TO: City of Raleigh Parks and Recreation Department
Falls Whitewater Steering Committee

DATE: 10/5/2010

REFERENCE: Falls Whitewater Steering Committee Meeting #8
October 4, 2010

STEWART PROJECT NUMBER: C09047

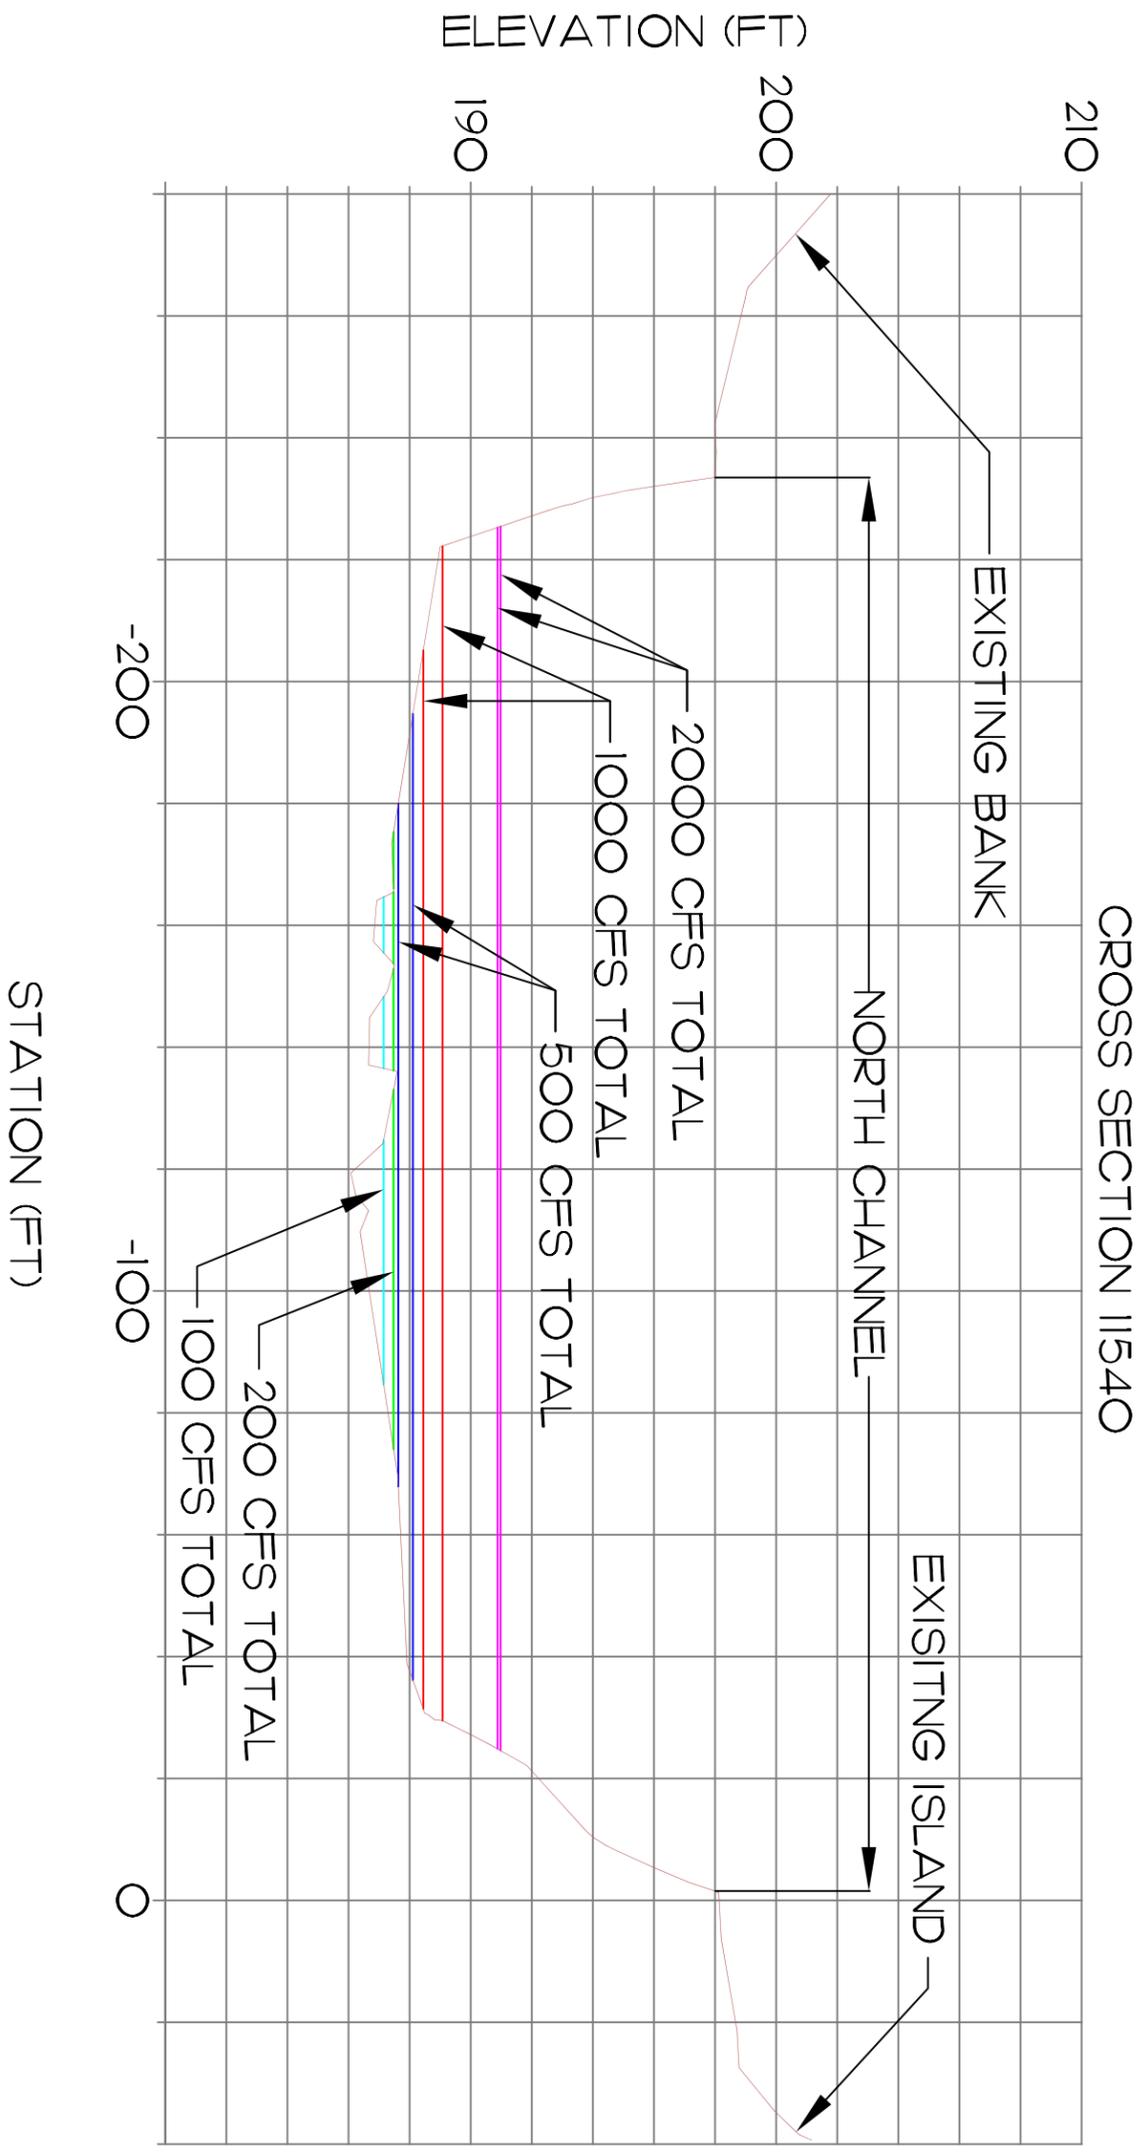
1. Diverter Island/Diversion Weir – The City staff will discuss the cost/benefit of such a device and ask the Steering Committee to vote on it.
2. Targeted Flow Volumes – John provided a chart and cross-sections to demonstrate impact on flow in the north channel.
